TECHNICAL BULLETIN

214ST-90-112 16 March 1990

Revision A, 30 August 2011

MODEL AFFECTED:214STSUBJECT:ROOF FRAME P/N 214-031-516-131, -132, -139,
AND -140, REPAIR/MODIFICATION OFHELICOPTERS AFFECTED:Serial number 28101 through 28200COMPLIANCE:At the customer's option prior to identification of a
crack.Frame should be repaired before crack reaches 1.0
inch in length.It is recommended this bulletin and Technical Bulletin
214ST-89-102 be accomplished concurrently.

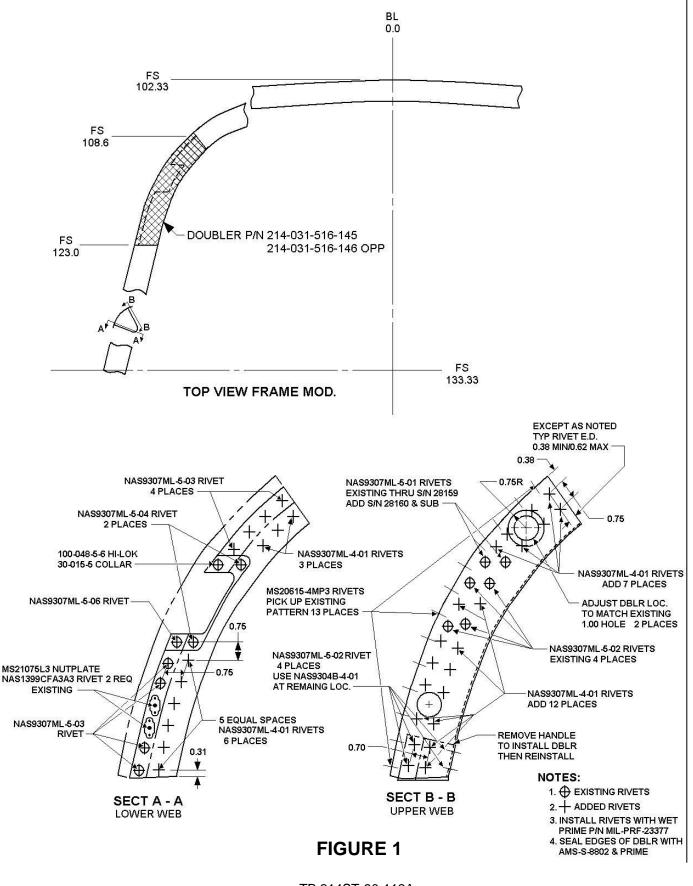
- 1. Locate repair doubler P/N 214-031-516-145 over roof frame P/N 214-031-516-131 as shown in Section B-B of Figure 1. Mark end with felt tip marker.
- 2. Remove rivets in area to be covered with repair doubler and handle.

3. Nest repair doubler over frame with 1.00 inch holes aligned and clamp in place. Verify fastener ED, then drill doubler to match all existing fastener locations shown in figure. Stop drill any crack in frame.

Layout new rivet locations. Progressively drill (number 30 for (-4) rivets and number 20 drill for (-5) rivets). Cleco parts together as they are drilled. See Section A-A for rivet pattern in lower web of frame (outboard rivet locations established during TB 214ST-89-102 incorporation). See section B-B for rivet pattern in upper web. Trim ends of doubler as shown.
